**5th IHO HSSC Meeting  
Shanghai, China, 5-8 November 2013**

**Paper for Consideration by HSSC**

**Comments by Finland  
to the status of S-57, scope of S-58 and the authority between S-57 and S-58**

**Submitted by:** Finland

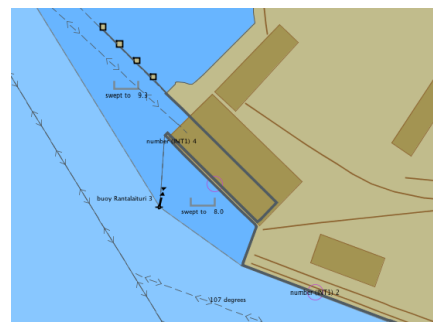
Finland has a real world case with All Weather Terminal like in pictures below.

We believe this encoding feasible because inside the building there is a navigable water area and this area and the building (BUISGL) overlap.

When testing this with e4.2.0 S-58 Test 54, this causes a Warning. This is correct because the situation is true but exceptional, and the operator should check that this is not an unintentional error.

On ECDIS screen this looks like in picture right. (coastline and part of fairway can be seen inside a dark brown building; water colour covered by dark brown, but in practice there is a depth area not land area.)

While testing this with the proposed e5.0.0 S-58 Test 54a (“For each CRANES, BUISGL, FORSTC, LNDMRK or SILTNK object of type area that is not WITHIN a LNDARE, BRIDGE, FLODOC, OFSPLF or PONTON object of type area.”), it returns a **Critical Error**.

In our understanding in this case when encoding according to S-57 UOC and testing with the proposed version of S-58 we receive a Critical Error. This should be corrected.

13. In addition, Finland requests the level of Test 54a to be changed back as a *Warning* before final approval of e5.0.0 of S-58.
